APP-GW-GLN-016, Revision 0

“AP1000 Licensing Design Change Document for Generic Reactor Coolant Pump”

TITLE: **AP1000 Licensing Design Change Document for Generic Reactor Coolant Pump**

Brief Description of the change (what is being changed and why):

Revised Figure 5.1-5 Sheet 3

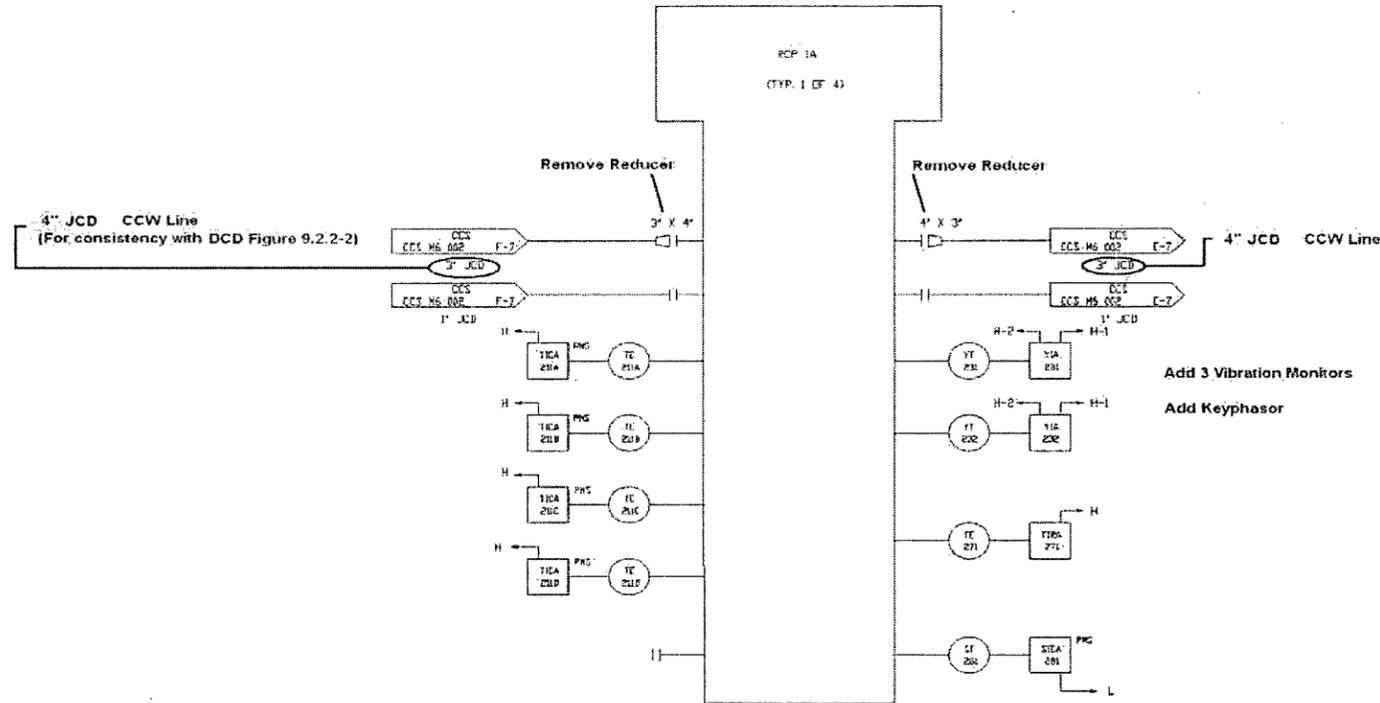
Revise Figure 5.1-5 Sheet 3 according to markup on next page:

Add 3 Vibration Monitors per Pump
 RCP 1A 1B 2A 2B
 Existing 231A 232A 233A 234A
 231B 232B 233B 234B
 231C 232C 233C 234C
 Additional 231D 232D 233D 234D
 231E 232E 233E 234E

Add 1 Keyphasor per Pump
 RCP 1A 1B 2A 2B
 261 262 263 264

Figure 5.4-1
Reactor Coolant Pump

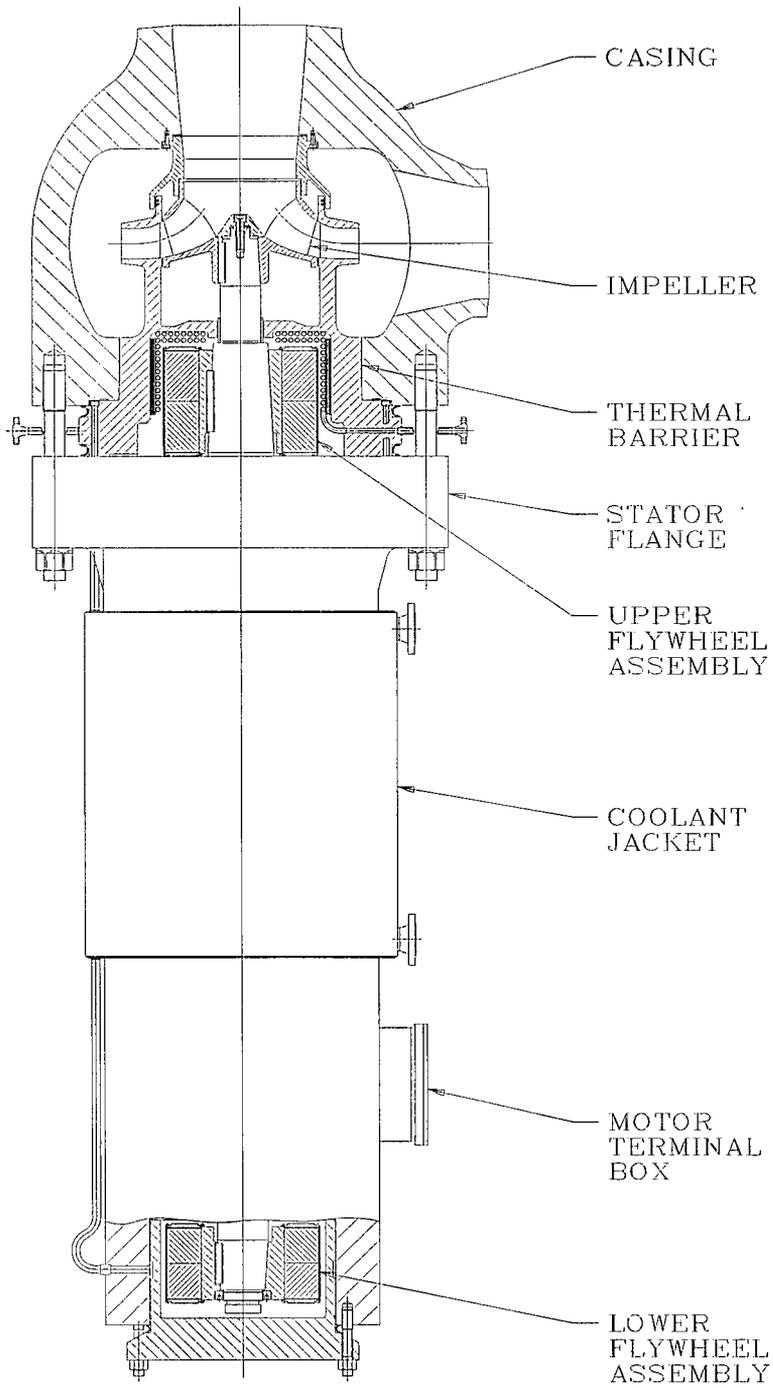
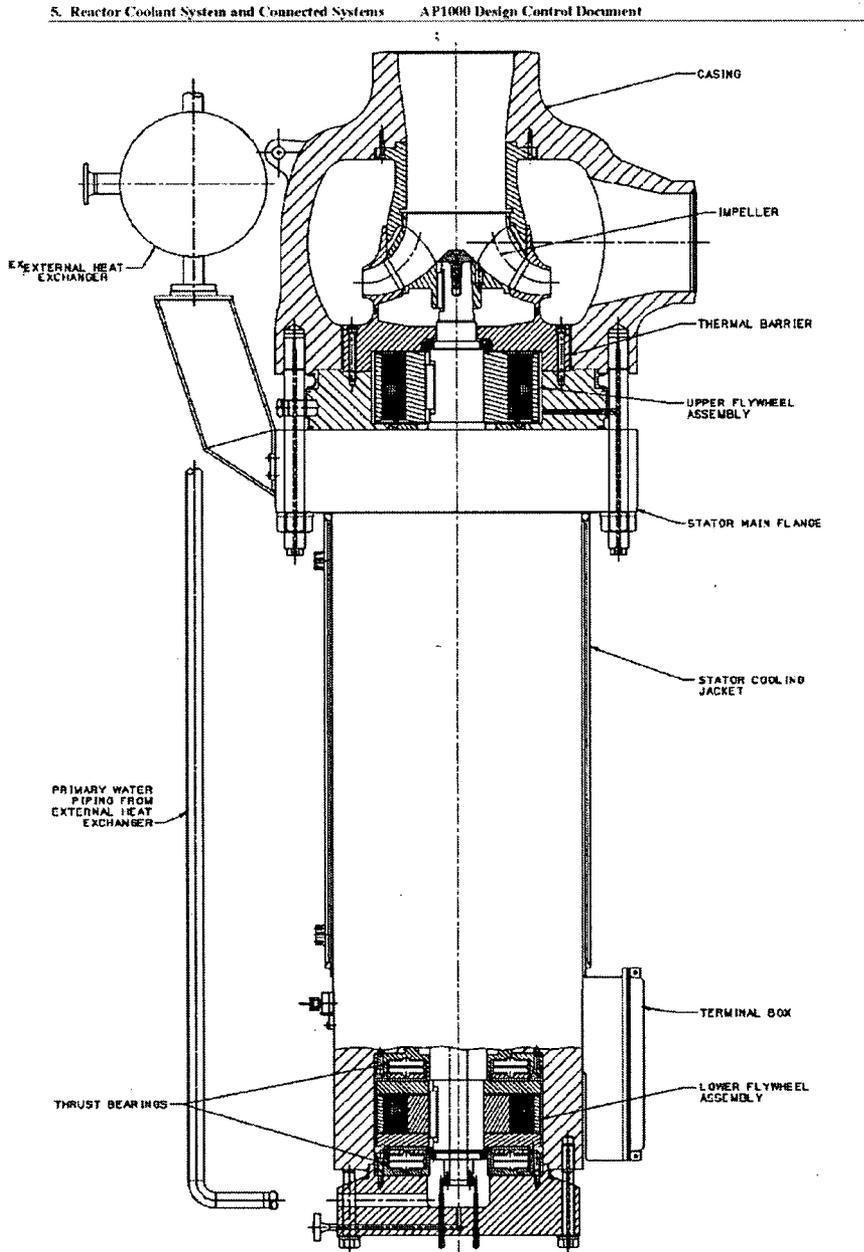
By increasing the inertia of the rotating assembly to maintain the pump coastdown required to support the safety analyses, the rotordynamics of the rotating assembly have been changed. To meet the rotordynamic requirements, the thrust bearing assembly has been modified from the previous configuration depicted in Tier 2, Figure 5.4-1.

The updated design incorporates the lower flywheel into the thrust bearing assembly. Two separate thrust runners are mounted with minimal clearance from the top and bottom of the lower flywheel. Upper and lower mounted thrust bearings borrow structural stiffness from the flywheel. In addition to providing acceptable and improved rotordynamics, the updated design provides the required inertia within the RCP space envelope while minimizing fluid frictional forces on the end faces of the lower flywheel.

- Tier 2: 5.4.1.2.1, 5.4.1.3.3, Figure 5.4-1

- Tier 2: 5.4.1.2.1, Figures 5.4-1, 5.1-5

- Tier 2: Figure 5.4-1

Revised Figure to Replace Figure 5.4-1:
